**TOWN OF PALM BEACH**  
Planning, Zoning & Building Department  
360 South County Road  
Palm Beach, FL 33480  
[www.townofpalmbeach.com](http://www.townofpalmbeach.com)

PLANNING, ZONING, & BUILDING DEPARTMENT  
PZ&B Staff Combination Memorandum: Architectural Commission and Town Council

SUBJECT: ARC-24-0085 (ZON-24-0044) 315 CHAPEL HILL RD

MEETING: JANUARY 29, 2025, ARCOM  
FEBRUARY 12, 2025, TC

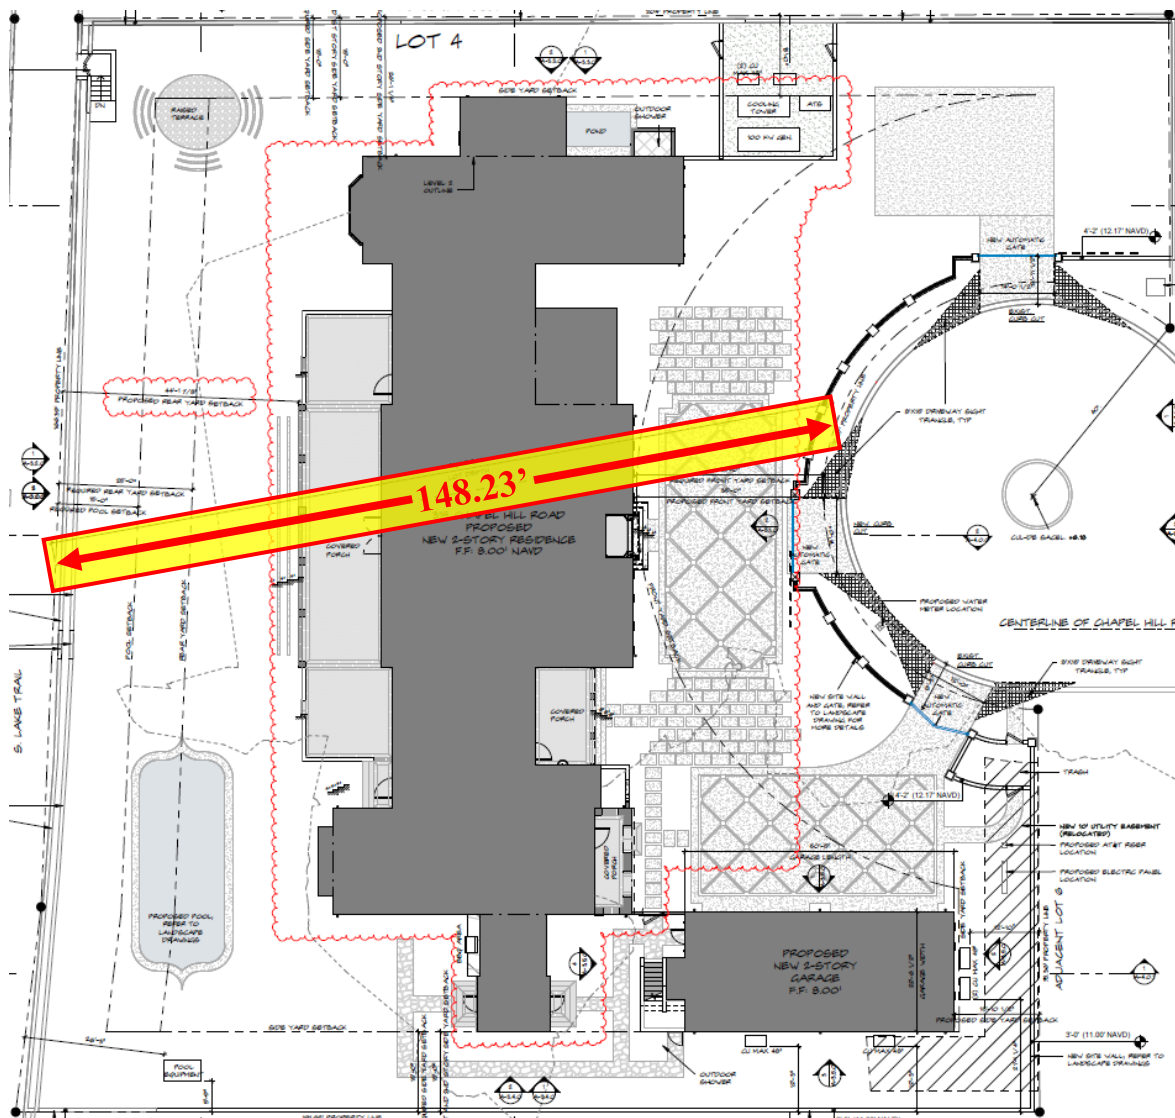
The proposed gates do require review and approval by Town Council. **Special Exception # 2** pertains to the setback distance of the vehicular gates from the Chapel Hill Road right-of-way. The zoning code requires that an 18'-0" deep vehicle queuing space be provided between the vehicle gate and the edge of the pavement to prevent a car from obstructing the roadway while waiting for the gate to operate. However, when the proposed gates are located on a cul-de-sac street, the Code permits pursuing a special exception for reduced queuing area (in lieu of a variance as would be required on a through-street). The existing residence on site has three curb-cuts all with vehicular gates. In addition to the subject parcel, one other residence on the street has a vehicular gate.

Code Section	Required	Existing/Proposed	Difference
SPECIAL EXCEPTION 2: Sec. 134-1668	18' Vehicle Loading Space at Drive Gate	10.33' (1) West Gate 9.25' (2) North Gate 8.58' (3) South Gate	-7.67' (1) West Gate -8.04' (2) North Gate -9.42' (3) South Gate

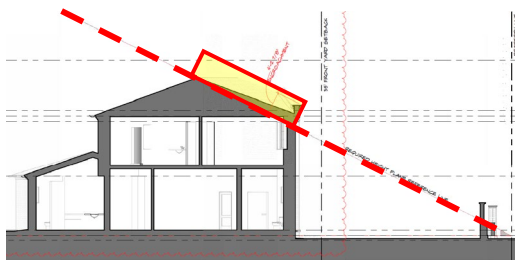
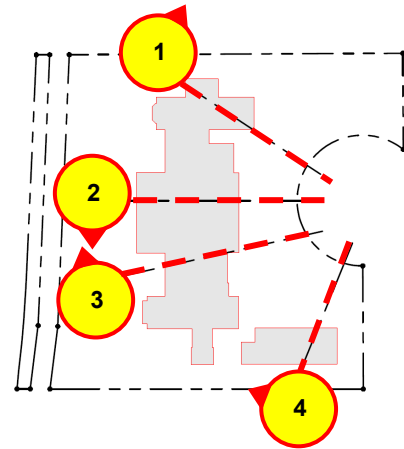
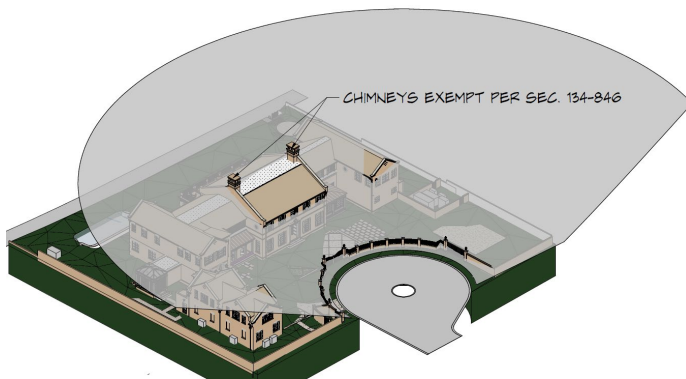
**Special Exception # 1** pertains to the depth of the lot. The lot is an irregular shape with a concave arc along the front property line as it follows the shape of the cul-de-sac. Due to the zoning code definition of lot depth, the point where to measure the depth of the lot is along this arc, resulting in a lot depth of less than 150'-0" which is the minimum lot depth required for the R-A zoning district. If the lot depth was to be measured along the north or south property lines from east to west, the depth would be conforming at approximately 200'-0". To note, the requested special exception is for an irregularly shaped lot that is only 1.77' deficient at its shaped most pinched point.

Code Section	Required	Existing/Proposed	Difference
SPECIAL EXCEPTION 1: Sec. 134-843(b)	150' Lot Depth	148.23' Lot Depth	-1.77' Lot Depth

*Building height plane encroachment 1 (4.24')*

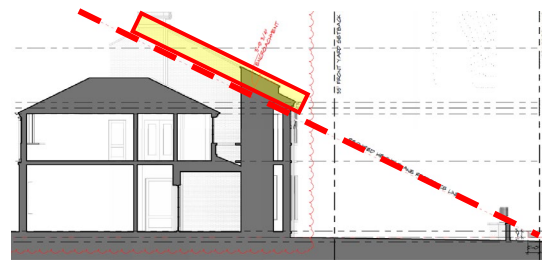
As it pertains to the **Variance** request, the applicant is proposing to construct the new residence beyond the building height plane limitation. The code states that no portion of any building or roof system shall extend beyond a height limiting plane extending at an inclined angle from the intersection of the front yard property line and zero datum. To determine the angle of the building height plane, two feet of setback are required for every one foot in building height. Due to the peculiar shape of the lot, the building projects anywhere between 3.48' to 5.21' beyond the building height plane.

Code Section	Required	Variance
VARIANCE 1: Sec. 134-843(7)	2' setback for every 1' building height	+3.48' – +5.21' Encroachment
